State of Alaska
Department of Fish and Game
Nomination for Waters
Important to Anadromous Fish

Anadromous Water Catalog Volume Southeastern, Region I

Name of Waterway unnamed

Anadromous Water Catalog Number of Waterway 103-25-10280

(3) Craig (B-2)

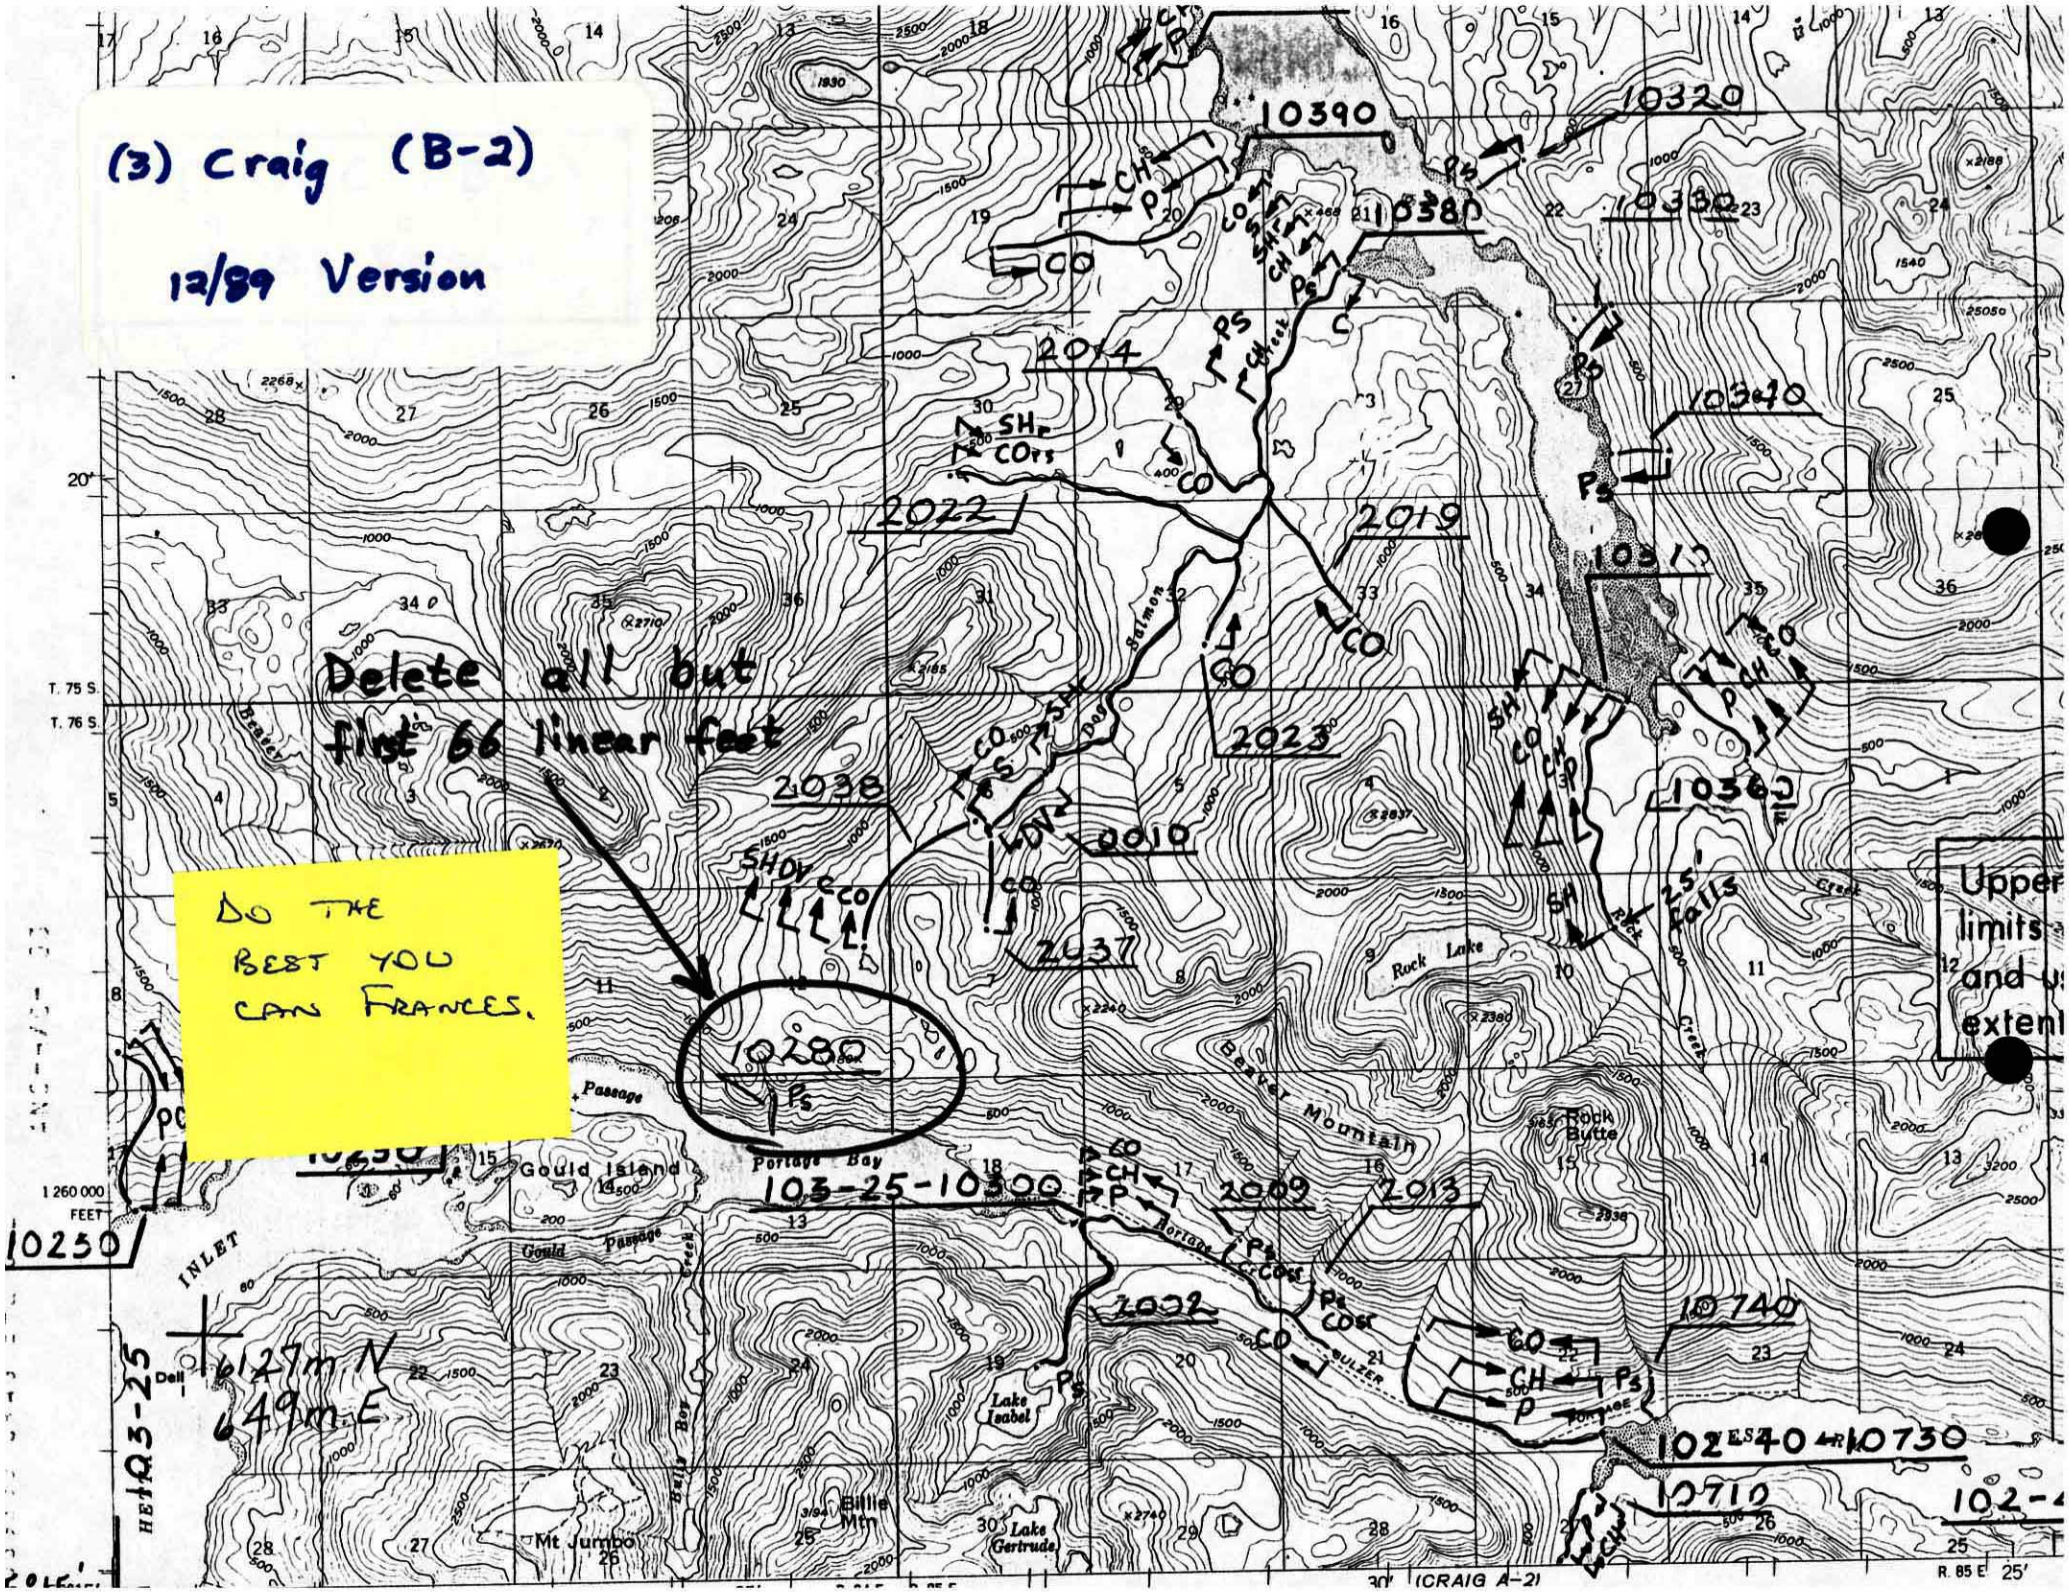
Comments: Provide any clarifying information, including number of fish observed, location of fish survey data, etc. This stream was examined during a March 6, 1991 field inspection. A 32' reach of rocky 12% extends from mean high tide to a 34' reach of 4% gravels, apparently suitable for pink salmon spawning. At the head of the 34' of gravel, a 5-6' falls leads up to a series of falls & rock steps, an apparent anadromous fish barrier. Delete all but the first 66 linear feet of this stream from the atlas and catalog.

Delete all but first 66 linear feet

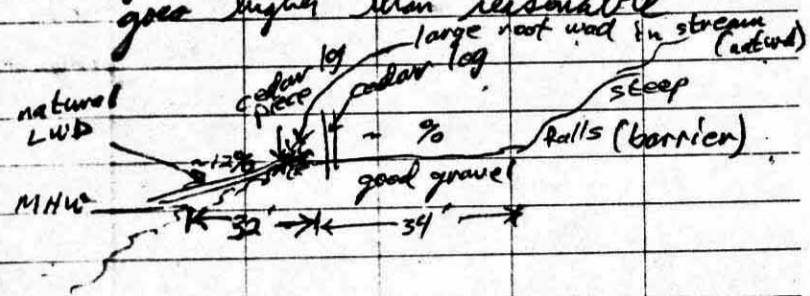
Beaver Creek, w/ Bruce Askearn, Dave Archambault, Chris Bradberry STC, Matt, Chris, Al
0730 Temsco KTN-KLW
in on 6000 road, work done since last visit (6 Feb.); went out 7000 road to end, just short of V-notch for stream #103-25-10280; ROW cleared to stream; several logs + brush in stream; took photos + measurements; atlas goes higher than reasonable

most debris in stream is above barrier; several (4?) logs
